From: Byers, Harris <Harris.Byers@stantec.com>
Sent: Wednesday, April 13, 2022 3:45 PM
To: Beggs, Tauren R - DNR <Tauren.Beggs@wisconsin.gov>
Cc: Adam Tegen <ategen@manitowoc.org>
Subject: Charging Soils Below Buffalo Street Extension

RIVER POINT DEVELOPMENT - PHASE 1
CITY OF MANITOWOC
MANITOWOC, WISCONSIN

From: Byers, Harris <Harris.Byers@stantec.com>
Sent: Wednesday, April 13, 2022 3:35 PM
To: Beggs, Tauren R - DNR <Tauren.Beggs@wisconsin.gov>
Cc: Adam Tegen <ategen@manitowoc.org>
Subject: RE: Construction of Temporary Greenspace at River Point

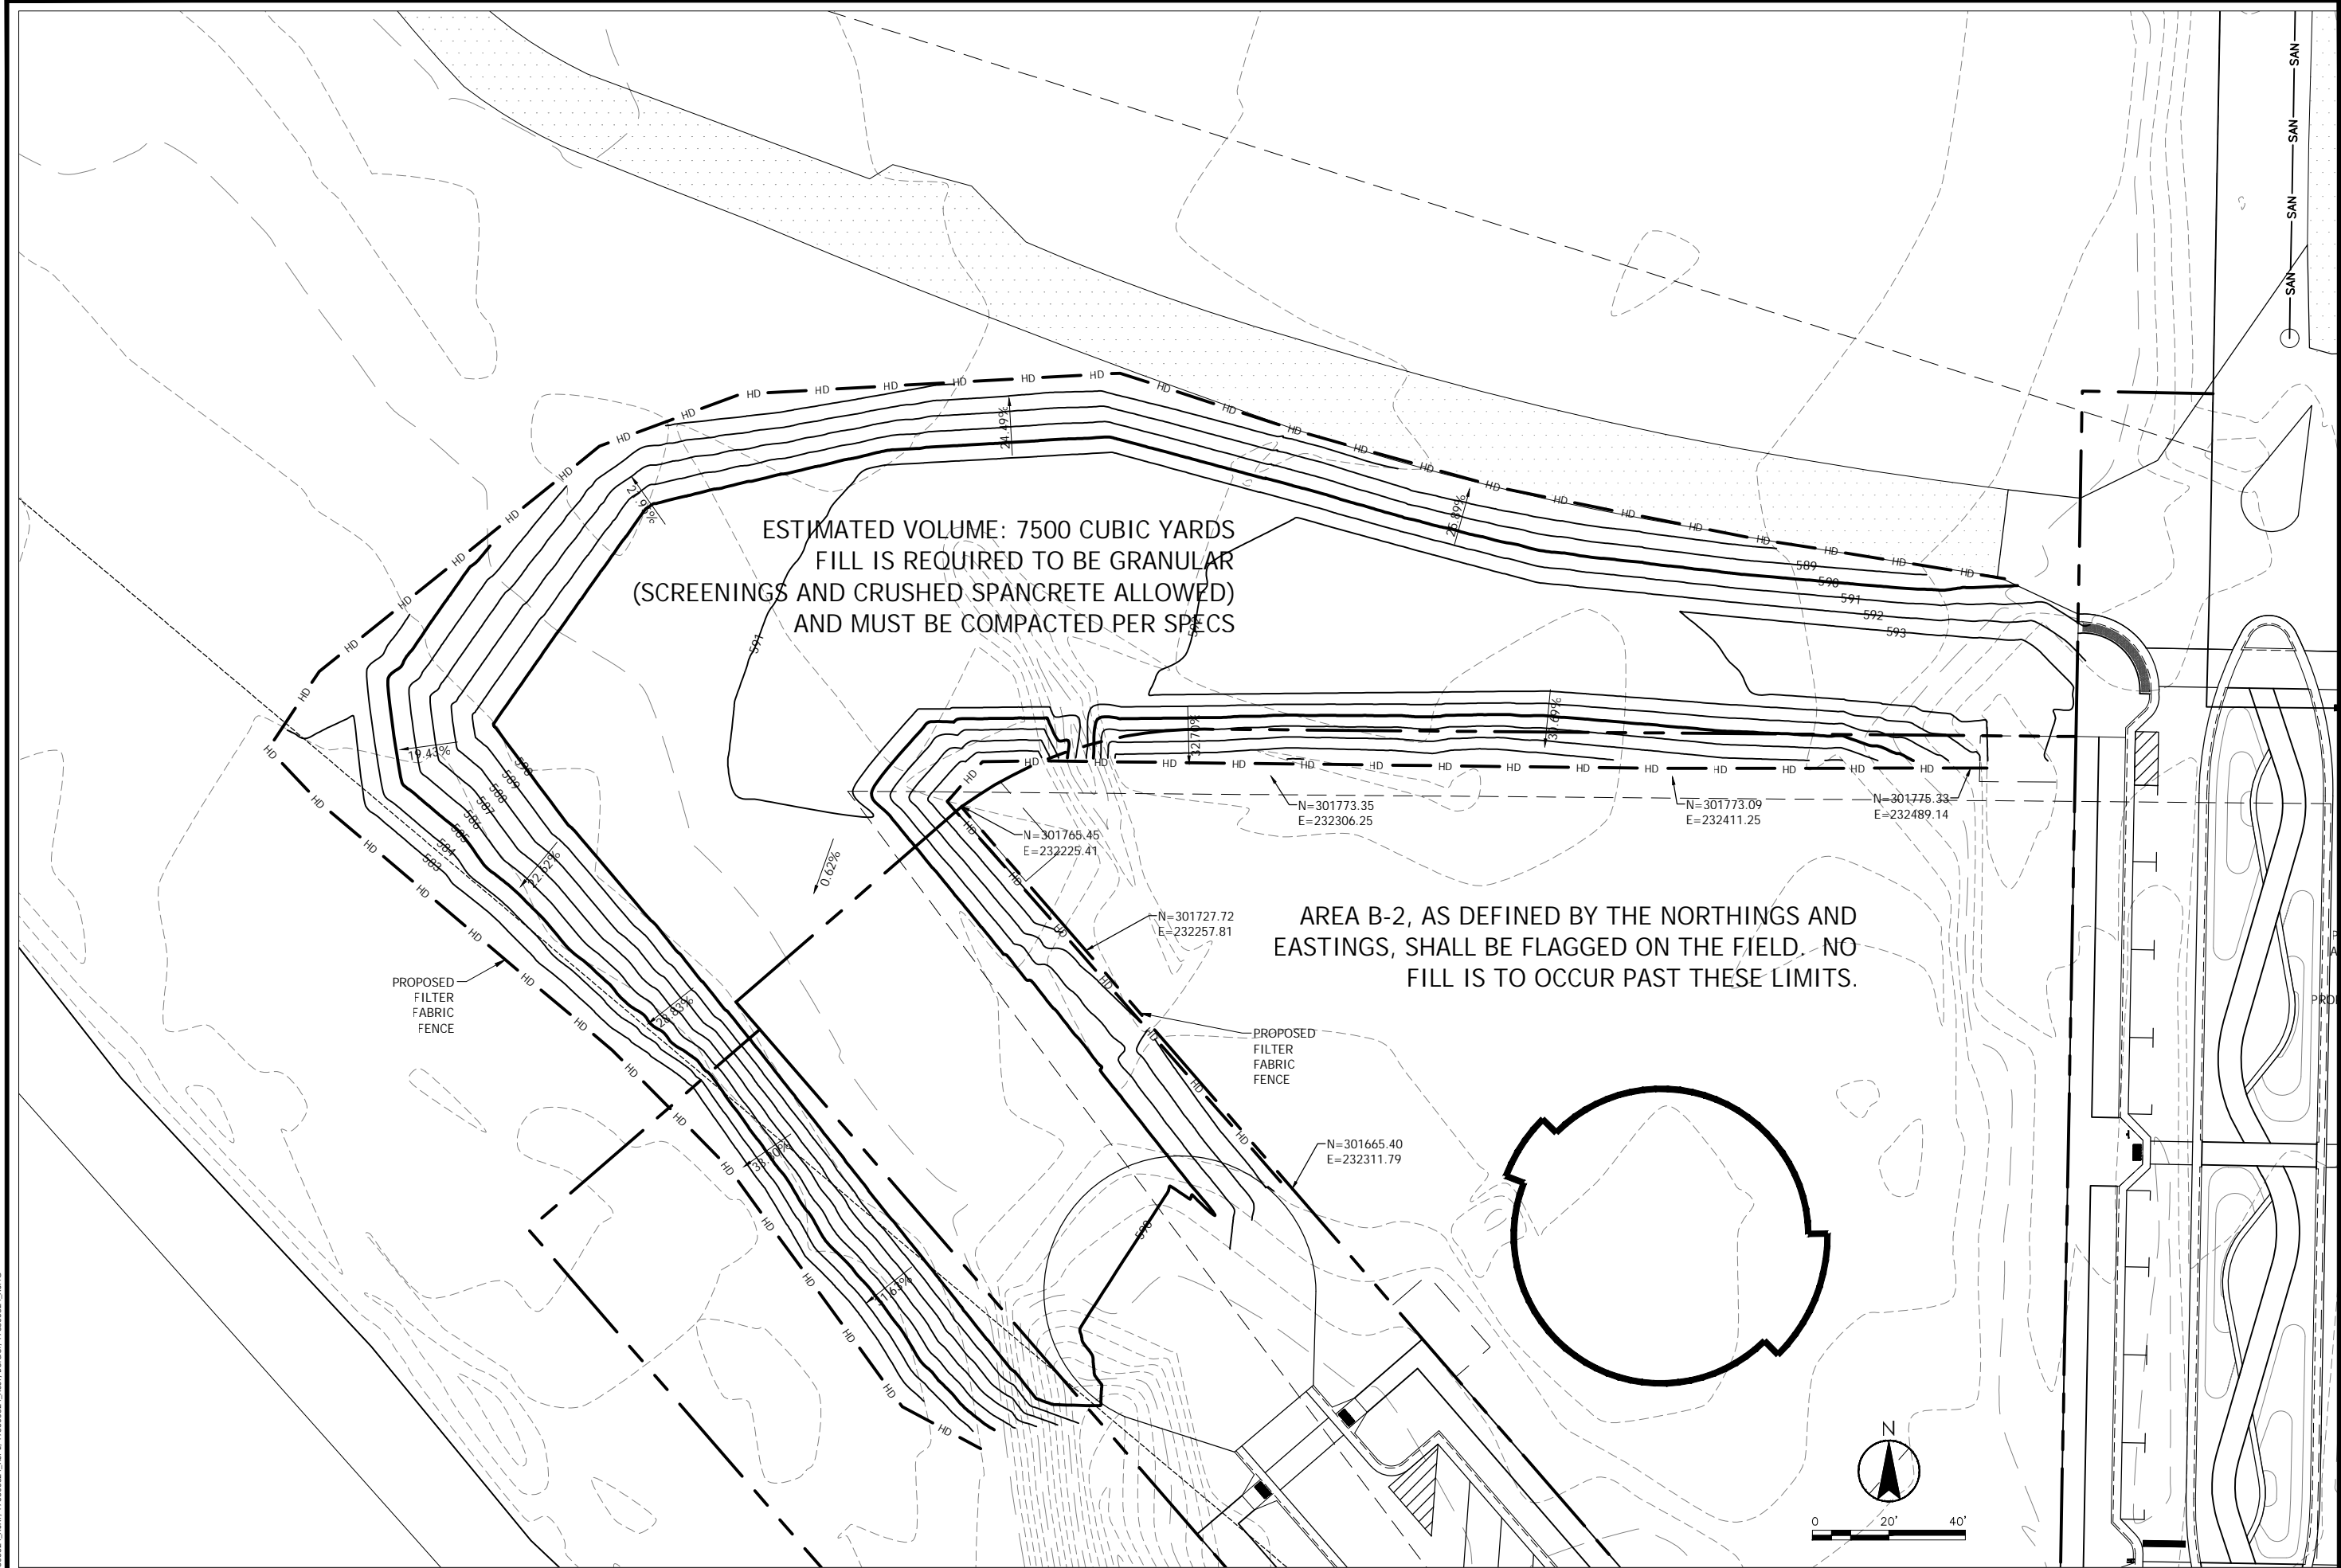
The City is working to final grade the roadways in the Phase I Construction Area ahead of asphalt paving next week. The final grading is expected to generate 7,000 or more yards of clean imported limestone screenings placed last year in the rights of way to charge the compressive soils at depth.

To start charging the compressive soils in the next rights of way and as a beneficial reuse, the City would like to place the cut limestone screenings in the future Buffalo Street and River Point Drive extensions (see attached). This would effectively create a 3- to 4-foot-thick engineered barrier in this area. Placement of this material in the future rights of way will not complicate the next phase of investigation, which we will get underway as soon as the WEDC SAG application is submitted to underwriting.

As noted on the attached, fill will not be placed in Lot 3 (referred to as Area B2 on the attached), which will be entered into the VPLE program in the near future.

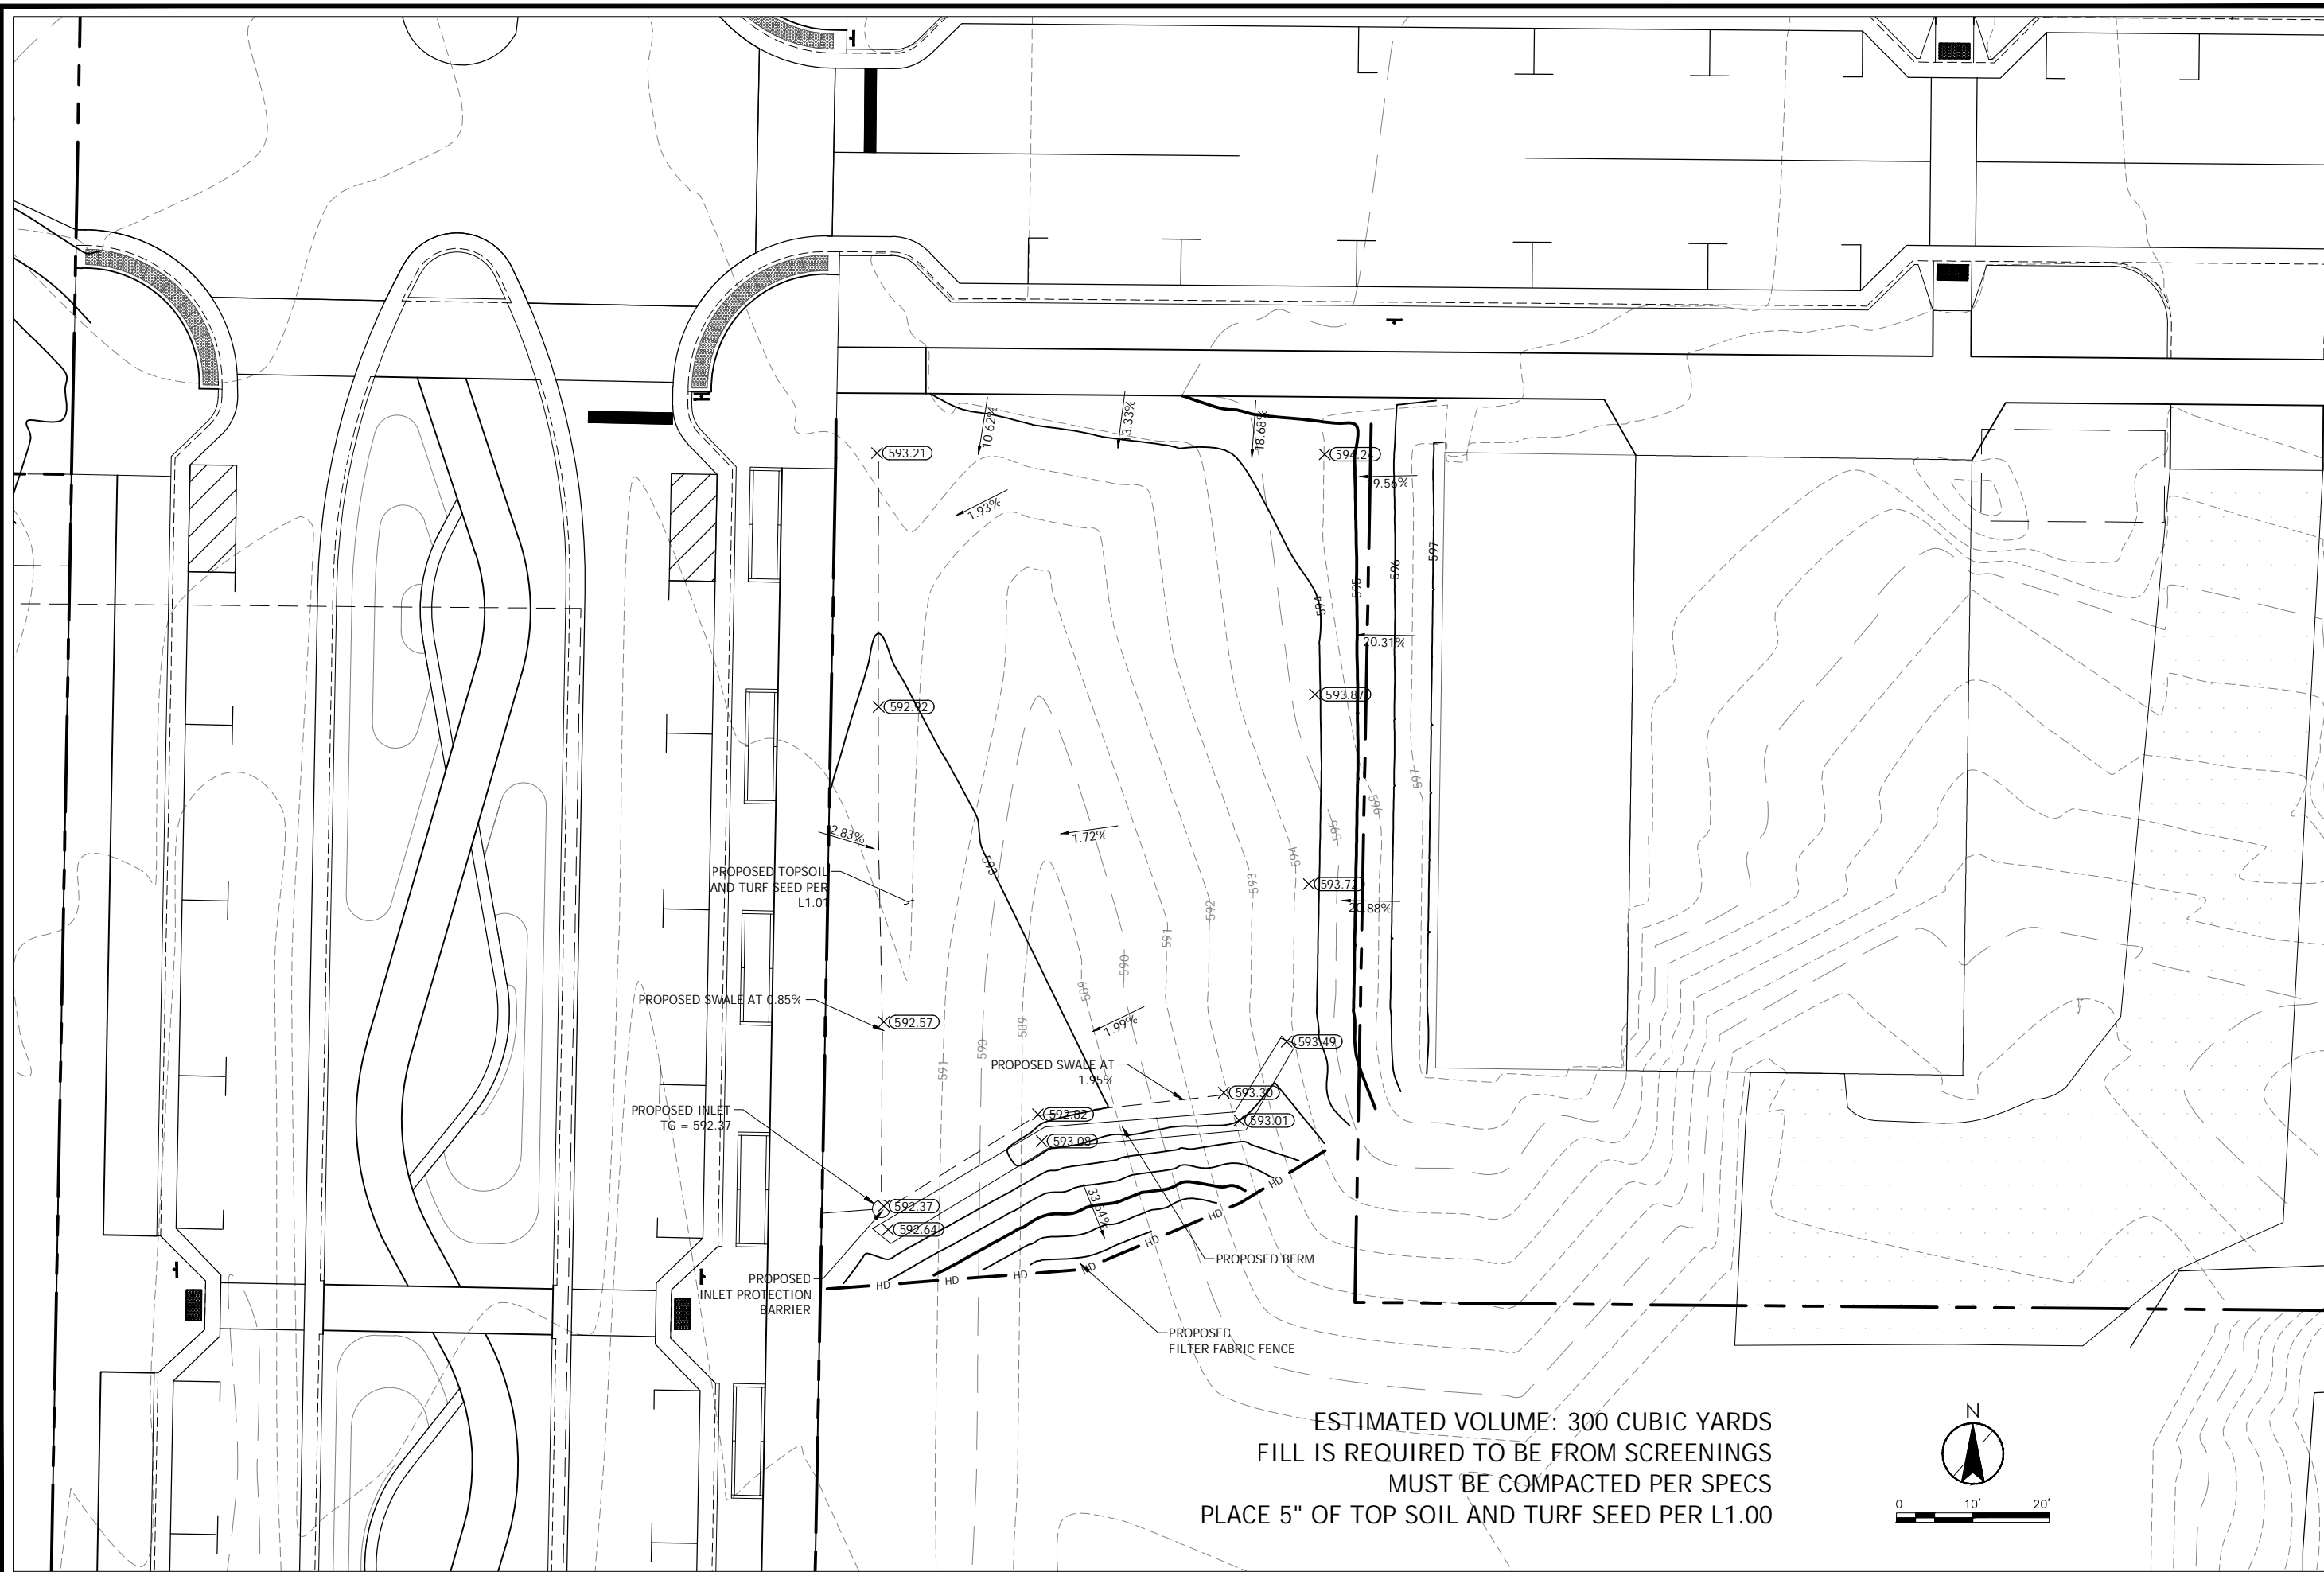
Our engineers had one final revision to the grading plan.

Looks like they are calling for 5" of topsoil instead of 6" as indicated in my initial email.

As we discussed, constructing the outdoor deck at PetSkull and construction of 11th Street created a valley that funnels stormwater to the former junkyard area south of PetSkull (see the light grey dashed lines on the attached grading plan).

To address these grades, as an interim use, the City would like to place approximately 500 cubic yards of clean limestone screenings previously imported to River Point to rough grade the area and finish the area with 6 inches of topsoil/grass (see dark lines on the attached grading plan). This would effectively create an engineered barrier ~5 feet thick that will be maintained by the City during this interim use as greenspace. I understand PetSkull may lease this greenspace from the City for outdoor recreation space.

ESTIMATED VOLUME: 300 CUBIC YARDS
 FILL IS REQUIRED TO BE FROM SCREENINGS
 MUST BE COMPACTED PER SPECS
 PLACE 5" OF TOP SOIL AND TURF SEED PER L1.00
